PHILADELPHIA ELECTRIC COMPANY

SUBJECT: Draft Limerick Generating Station, Units 1 and 2

FSAR Revisions to Incorporate the Extended Load Line

Region, Increased Core Flow, and Partial Feedwater Heating

TABLE 6.3-4 (Cont'd)

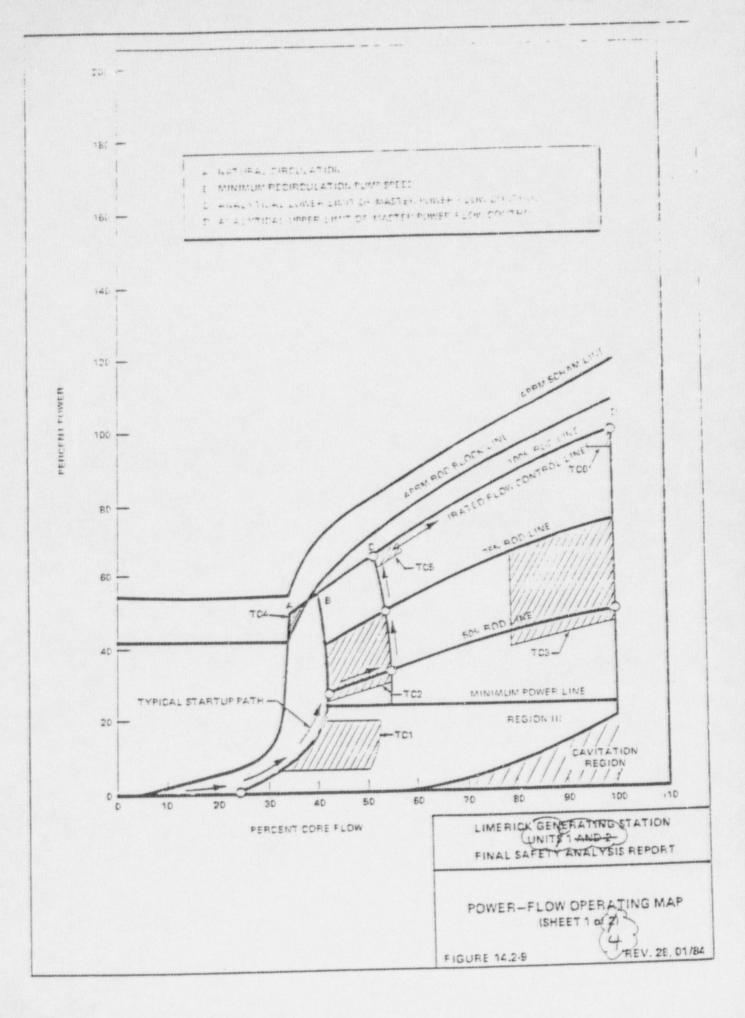
⁽²⁾ This analysis is valid for operation at all points on the power-flow map bounded by the most restrictive of the following:

a) Less than the 100% rated power line

b) Less than the APRM rod block line

c) Less than the 100% rated core flow line

FIGURE 14.2-9

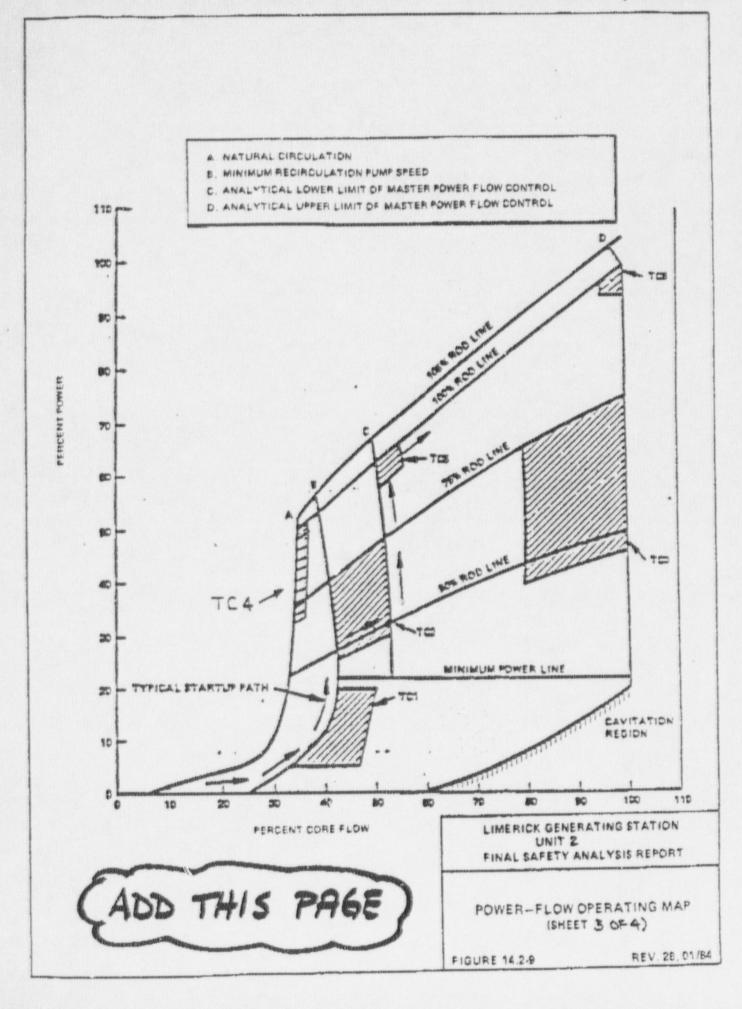
This letter provides markup of current FSAR pages (Enclosure 1) which are made to incorporate the extended load line region (ELLR), increased core flow (ICF), and partial feedwater heating (PFH) into the Limerick FSAR. These changes were discussed with NRC staff on May 11, 1989 and are consistent with the Final Draft version of the Unit 2 Technical Specifications transmitted by NRC letter dated May 19, 1989. The analyses supporting these operational conditions for Unit 2 are included as Enclosures 2 and 3. Enclosures 4 and 5 contain the corresponding General Electric affidavits to support a proprietary finding in accordance with 10CFR2.790 for the reports of Enclosures 2 and 3. The Unit 2 analyses are identical to the Unit 1 analyses which the NRC has previously accepted by safety evaluations dated February 17, 1987 (ICF and PFH), and August 14, 1987 (ELLR). The attached FSAR markup also updates the power flow map of Section 14. These proposed revisions will be incorporated in a future FSAR amendment.

Feedwater Controller Failure Without Turbine Bypass Figure 15.1-3A

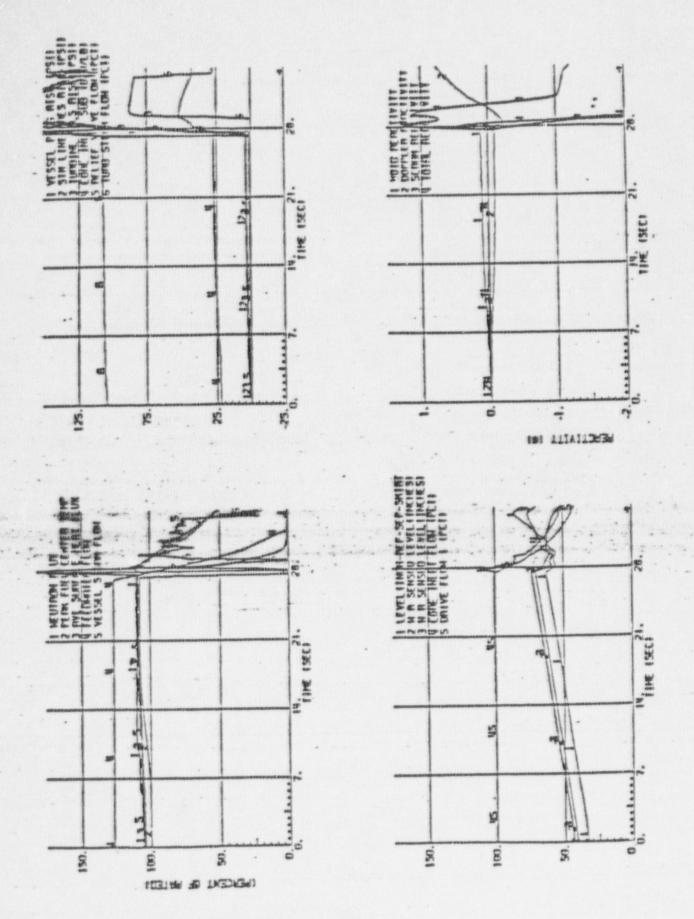
An additional transient has been considered for Limerick. The effects of an inoperative turbine bypass system in combination with the Feedwater Controller Failure, Maximum Demand transient described above were determined with an ODYN code analysis. The model, the initial conditions, and the operation of other systems is as described above, except that the operability of the turbine bypass is not taken credit for. The sequence of events with an inoperative bypass system is shown on Table 15.1-3A and the transient parameters are on Fig. 15.1-3A. The MCPR values for this transient are shown in Table 15.0-5.

(Add this ...)

Figure 15.A-2 Feedwater Controller Failure Without Turbine Bypass at 100% power, 87% Flow

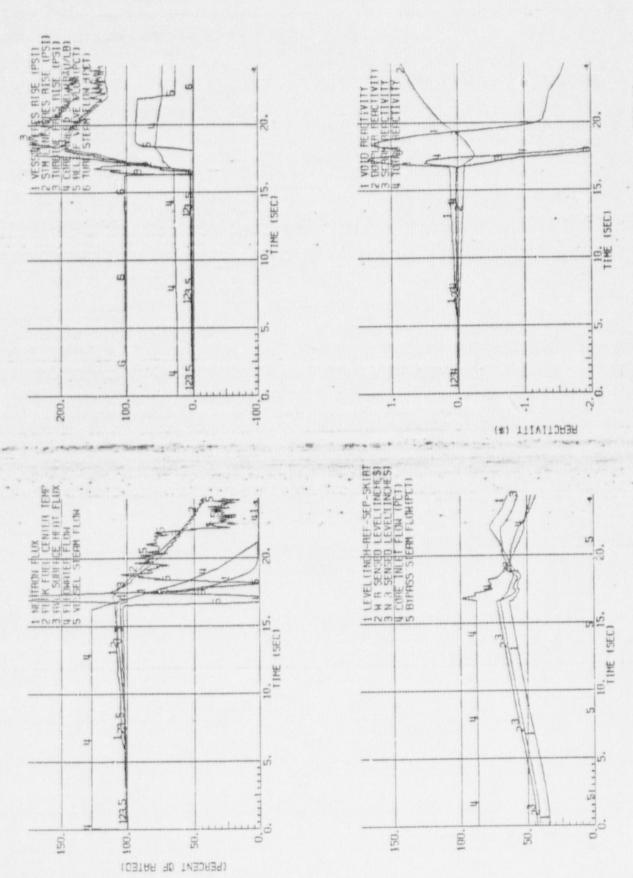
The limiting transient is determined to be the feedwater controller failure without turbine bypass for both the RPT system in and out-of-service cases. These events were analyzed using the computer model of Reference 15.A.10-1. The results of the limiting transients and their associated minimum critical power ratio (MCPR) limits for the initial fuel cycle are presented in Tables 15.A-1 and 15.A-2. The transient performance responses are shown in Figures 15.A-2 to 15.A-5. The details of all the analyzed transients are documented in References 15.A.10-2 to 15.A.10-5.

Figure 15.A-6 MSIV Closure, Flux Scram, 104.3% Power, 105% Flow

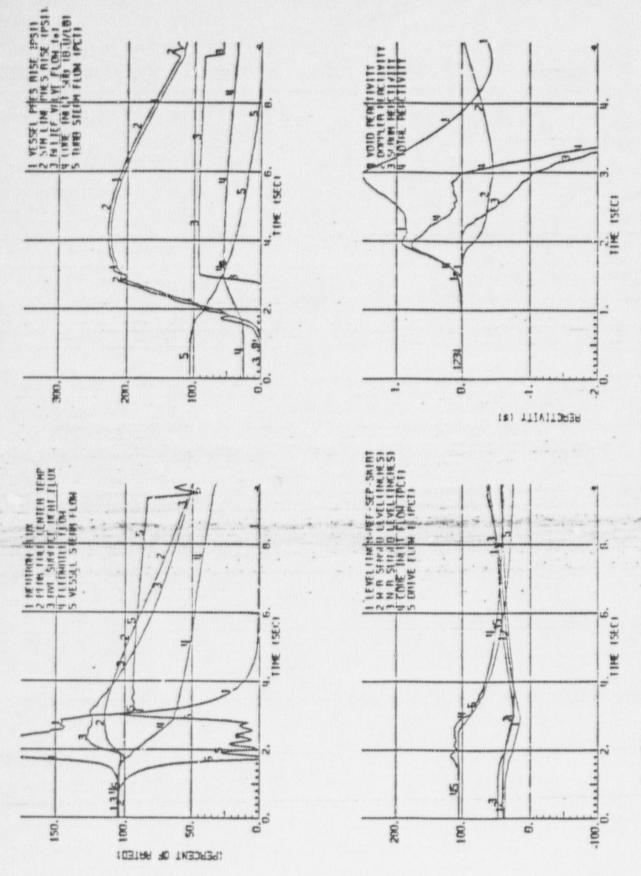
The limiting transient to satisfy the ASME Code overpressure protection criteria (FSAR Chapter 5) is the main steam isolation valve (MSIV) closure event with secondary (flux) scram. PFH and ELLR result in lower initial steam flow and operating pressure that enables the peak vessel pressure to be lower than the values reported in Chapter 5 for this limiting transient. The ICF analysis produces a higher peak vessel pressure. Its peak pressure of 1273 psig is still well below the ASME Code limit of 1375 psig. The peak pressure results for the initial fuel cycle analyzed cases are presented in Table 15.A-3. The transient responses for the ICF case are shown in Figure 15.A-6.
